**Proposed Temporary Open Storage of Construction Materials and Vehicles and
Associated Filling of Land for a Period of 3 Years in "Agriculture" Zone,
Various Lots in D.D.106, Shek Kong, Yuen Long, New Territories**

(S.16 Planning Application No. A/YL-SK/426)

Responses-to-Comments

Drainage Proposal

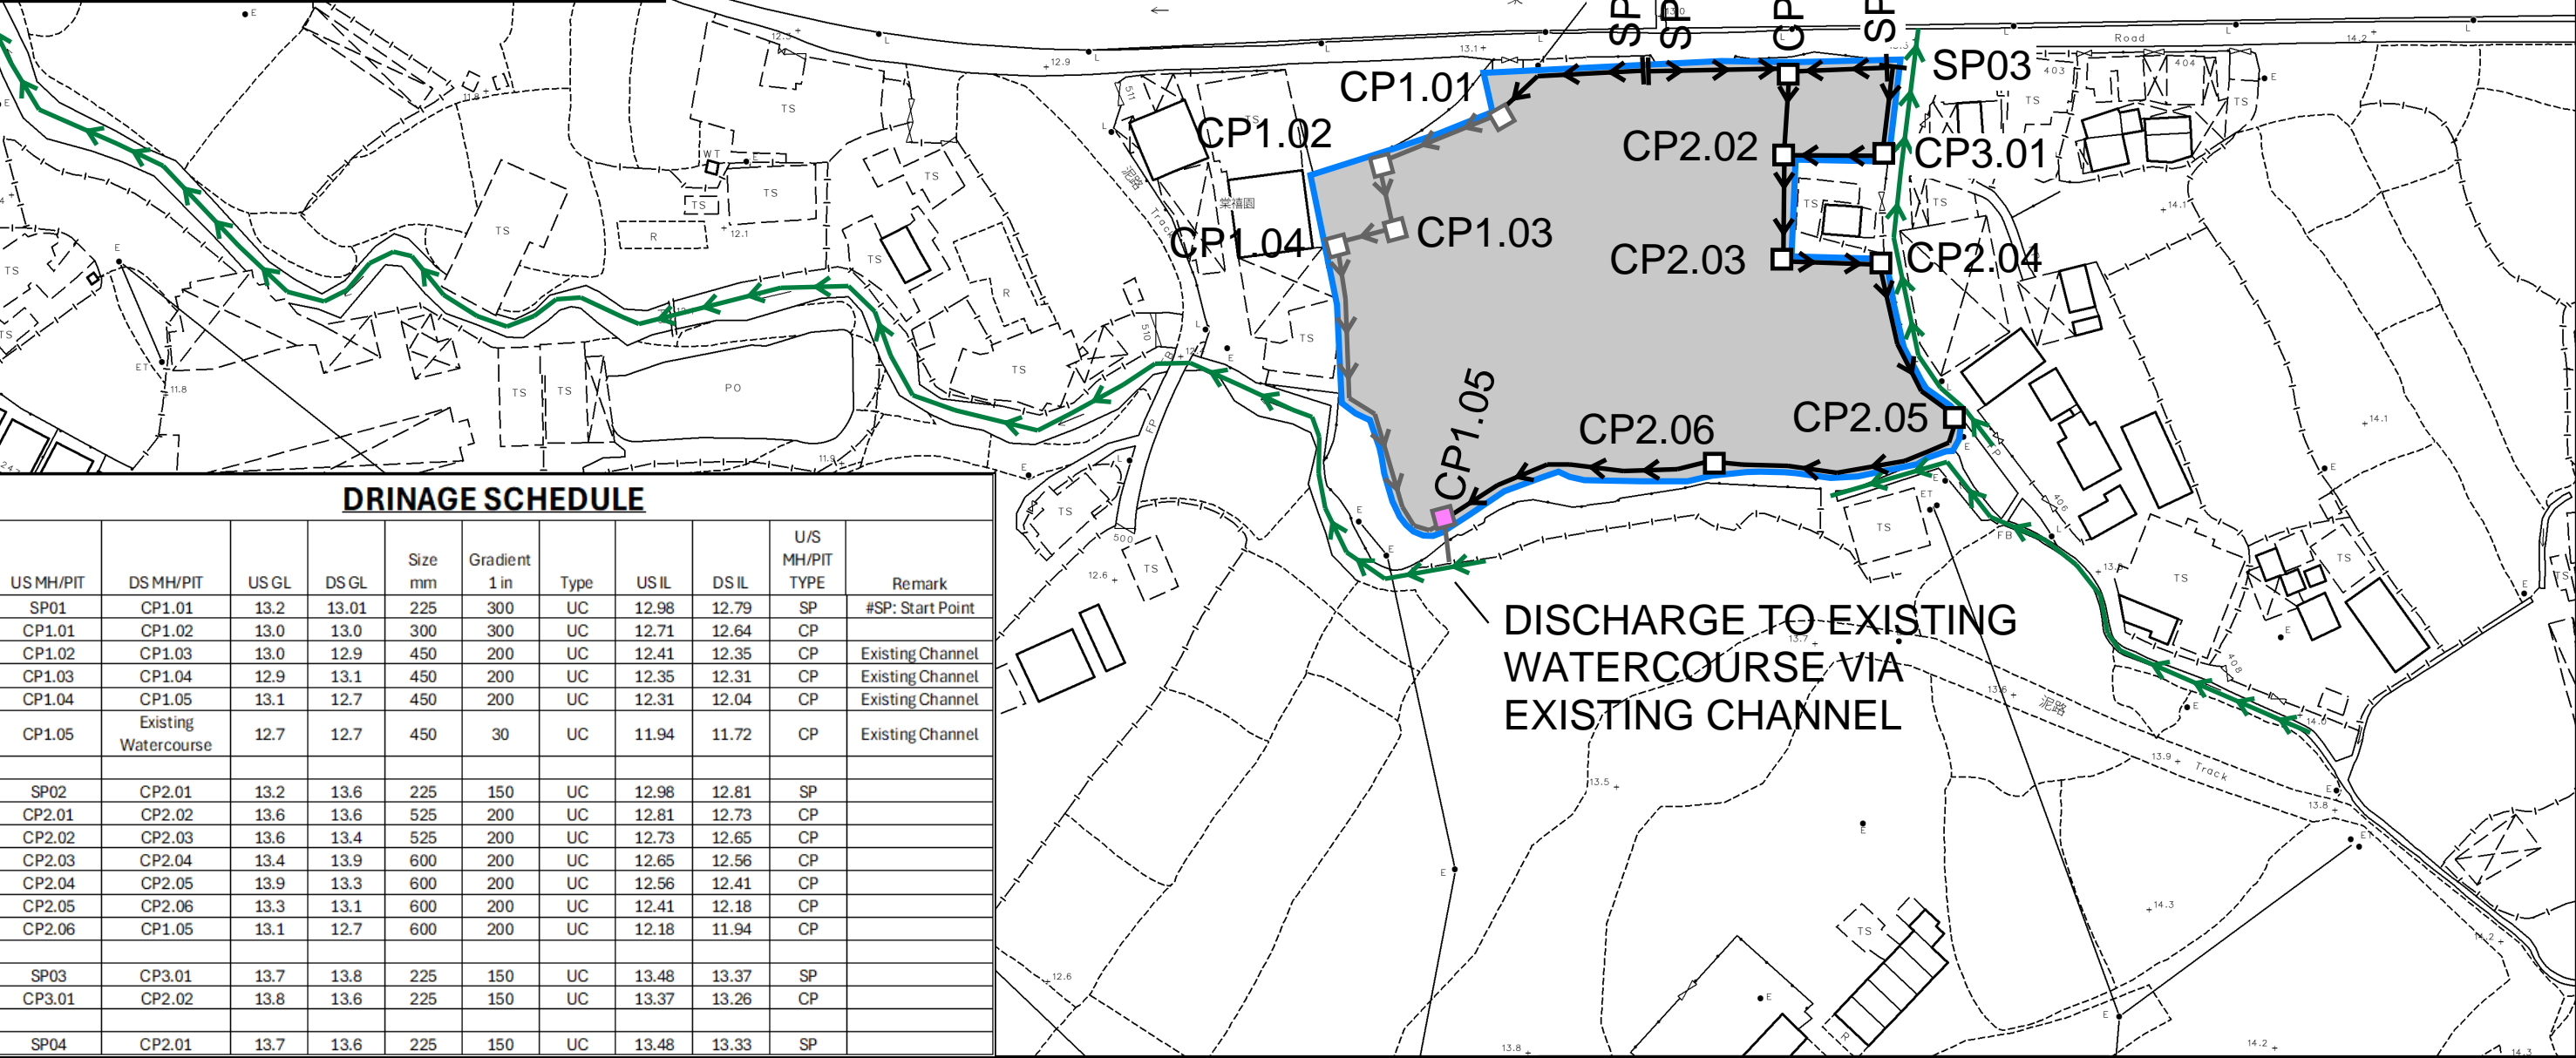
(l)	Connection details at discharged point (including cross section) with C.L., I.L and catchpit/channel bottom level should be shown in the drawing.	
(m)	Colour photos to indicate the current conditions of the existing drainage facilities should be included in the submission. The photos taken locations and angles should be shown on the layout plan.

- 1.2.1 The application site is situated at the south of Shek Kong Airfield. It has an area of approx. 6,427 m². The site location is shown in **Figure 1**.
- 1.2.2 The existing site is already fully paved. The existing site levels are approx. + 13.5 mPD. No major site formation works for the application site is anticipated.
- 1.2.3 The Application Site runoff is being discharged existing watercourse at the south of the site which would eventually discharge to Kam Tin River. **Figure 2** indicates the existing drainage system of the area.

TITLE
PROPOSED DRAINAGE SYSTEM

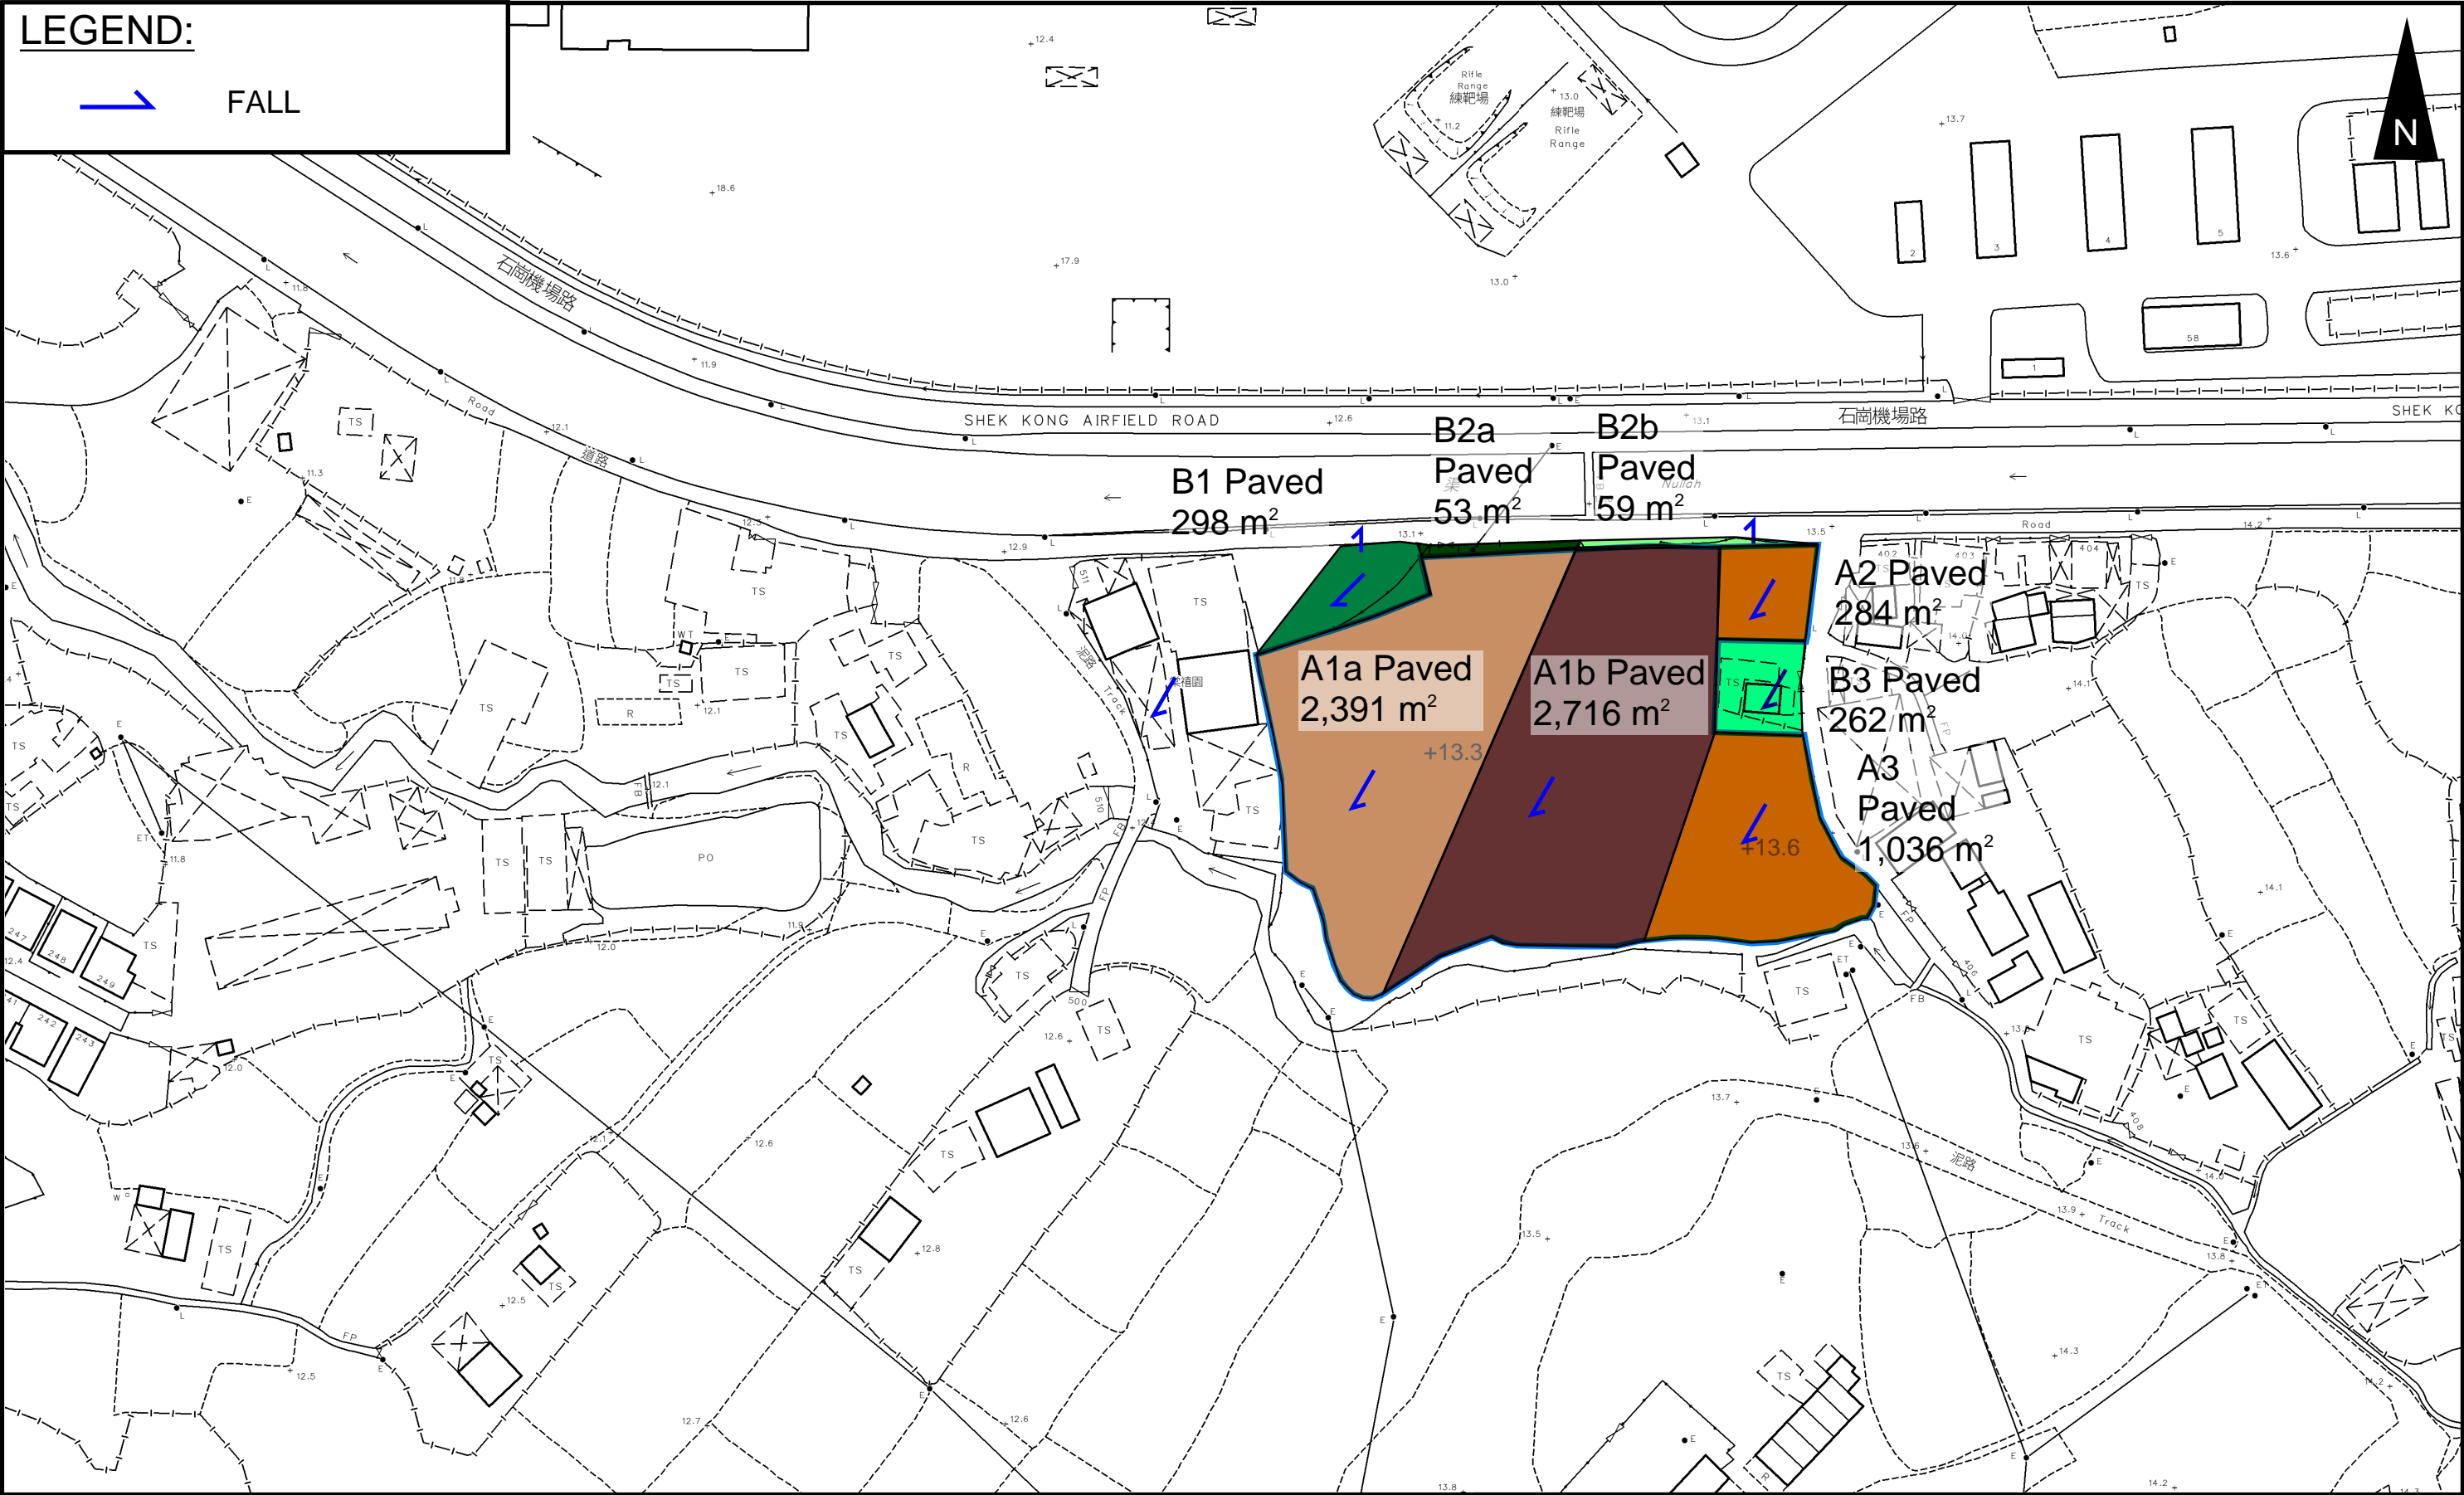
(d)	The size and gradient of the proposed/existing drainage facilities to be discharge from the site and/or the drainage plan. The applicant should check and ensure the hydraulic capacity of the existing drainage facilities would not be adversely affected by the captioned development.

(e)	Reference should be made to DSD Technical Note No. 1 for the sizes of the proposed u-channels.	
(f)	Where walls or hoarding are erected or laid along the site boundary, adequate opening should be

- 4.1.3 The design calculations of proposed UChannel are shown in **Appendix A**.
- 4.1.4 The alignment, size, gradient and details of the proposed drains are shown in **Figure 3**. The catchment plan is shown in **Figure 4**.

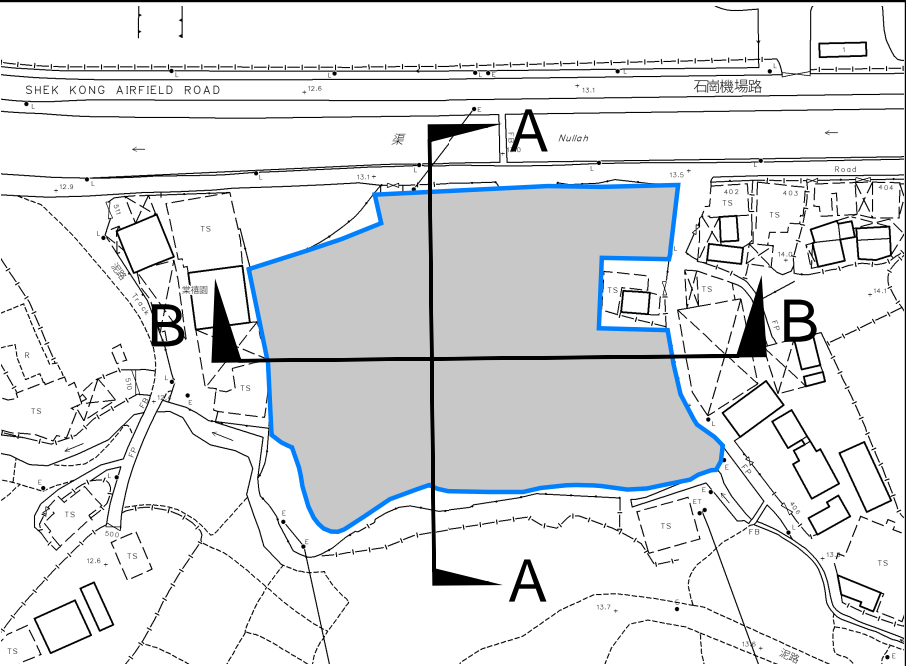
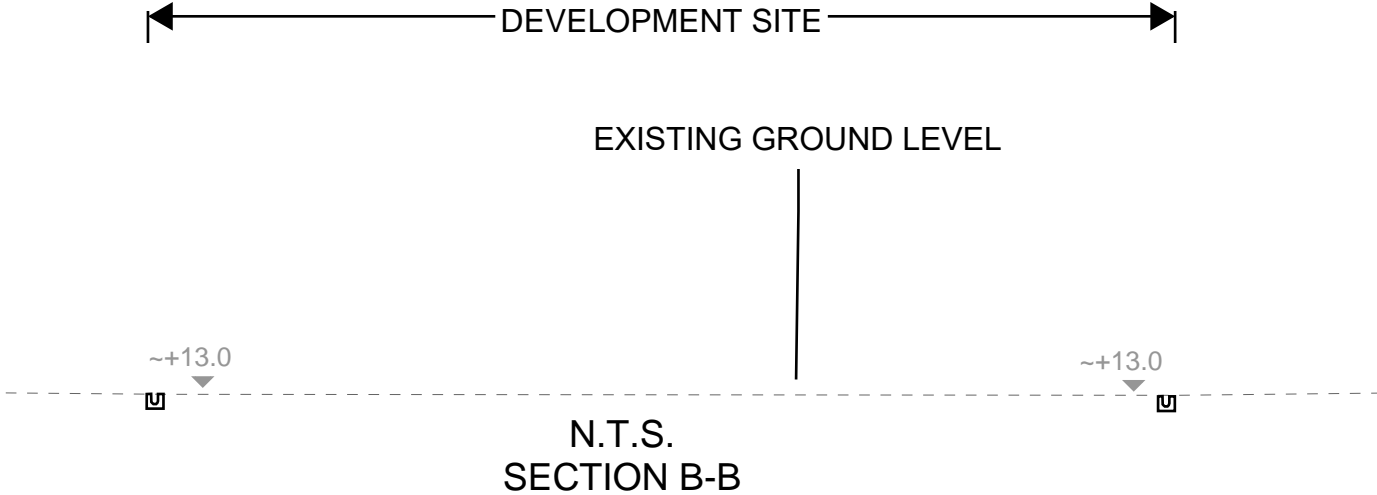
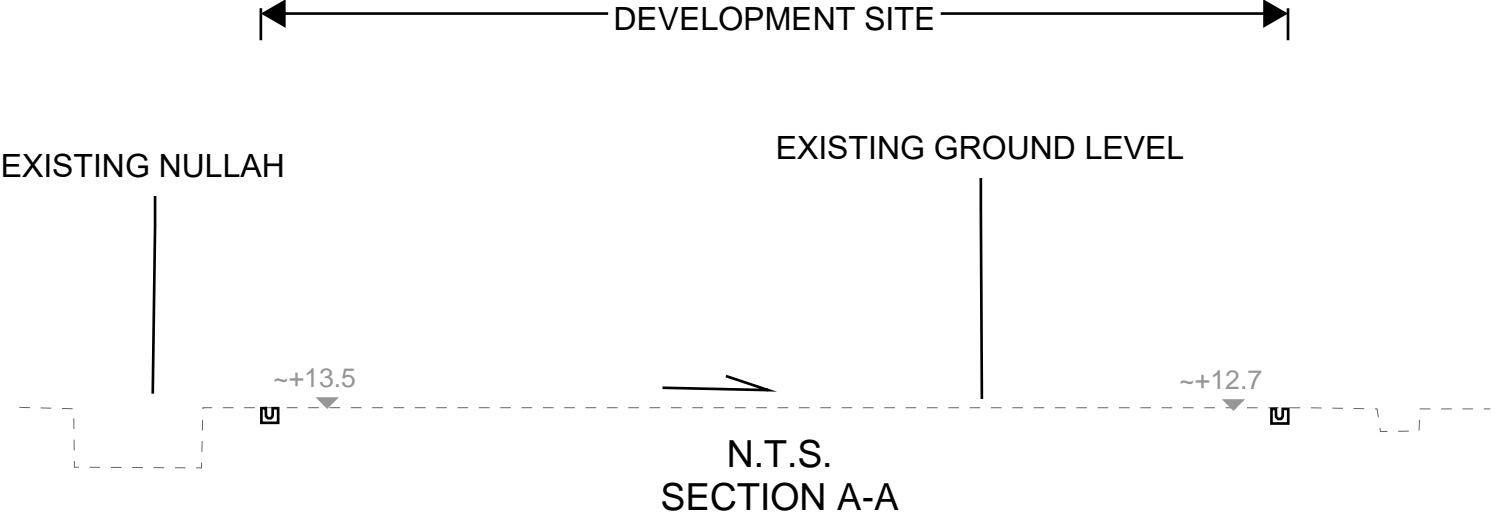
provided to intercept the existing overland flow passing through the site.	
(g)	Cross sections showing the existing and proposed ground levels of the captioned site with respect to the adjacent areas should be given.
